**Date** : 3/2/2020 4:03:32 PM  
**From** : "Kevin Arucan"  
**To** : "Debbie Lawrence"  
**Cc** : "Planning Major Projects" , "Wes Pringle" , "Pamela Teneza" , "Quyen Phan" , "Craig Bullock" , "Bhuvan Bajaj" , "Taimour Tanavoli" , "Matthew masuda" , "Jonathan Chambers"  
**Subject** : Assessment Letter for 6220 Yucca Street Mixed-Use Project  
**Attachment** : CEN18-46907\_6220 Yucca\_updated MU\_vmt\_ltr.pdf;

6220 W. Yucca St  
DOT Case No. Cen 18-46907

Subject: **TRANSPORTATION IMPACT ASSESSMENT FOR THE PROPOSED  
MIXED-USE DEVELOPMENT PROJECT LOCATED AT 6220 WEST YUCCA  
STREET**

FIGURE  
1

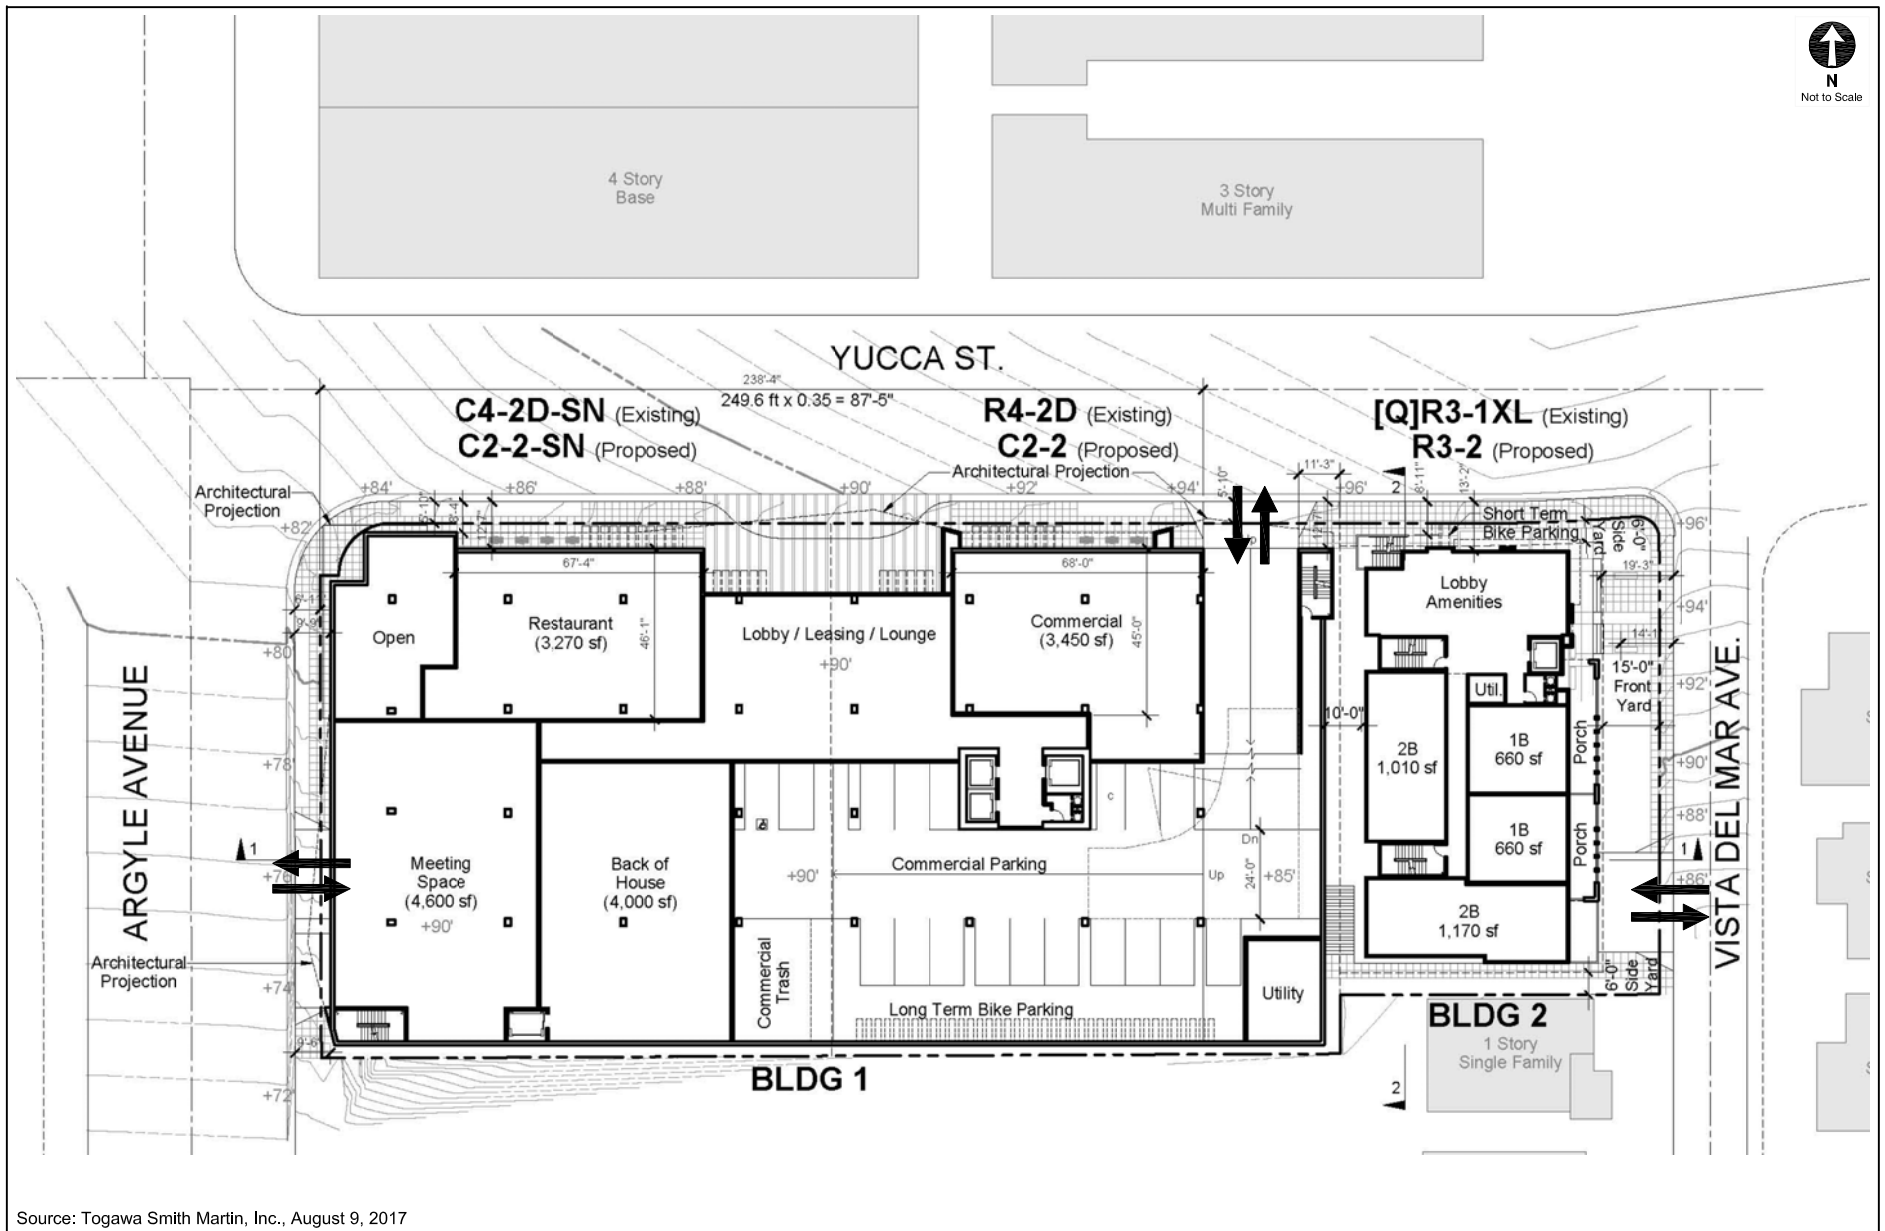
The proposed site plan illustrated in **Attachment A** is acceptable to DOT; however, review of the study does not constitute approval of the driveway dimensions and internal circulation schemes. Those require separate review and approval and should be coordinated with DOT's Citywide Planning Coordination Section (201 N. Figueroa Street, 5th Floor, Room 550, at 213-482-7024). In order to minimize potential building design changes, the applicant should contact DOT for driveway width and internal circulation requirements so that such traffic flow considerations are designed and incorporated early into the building and parking layout plans. All new driveways should be Case 2 driveways and any security gates should be a minimum 20 feet from the property line. All truck loading and unloading should take place on site with no vehicles backing into the project via any of the project driveways.
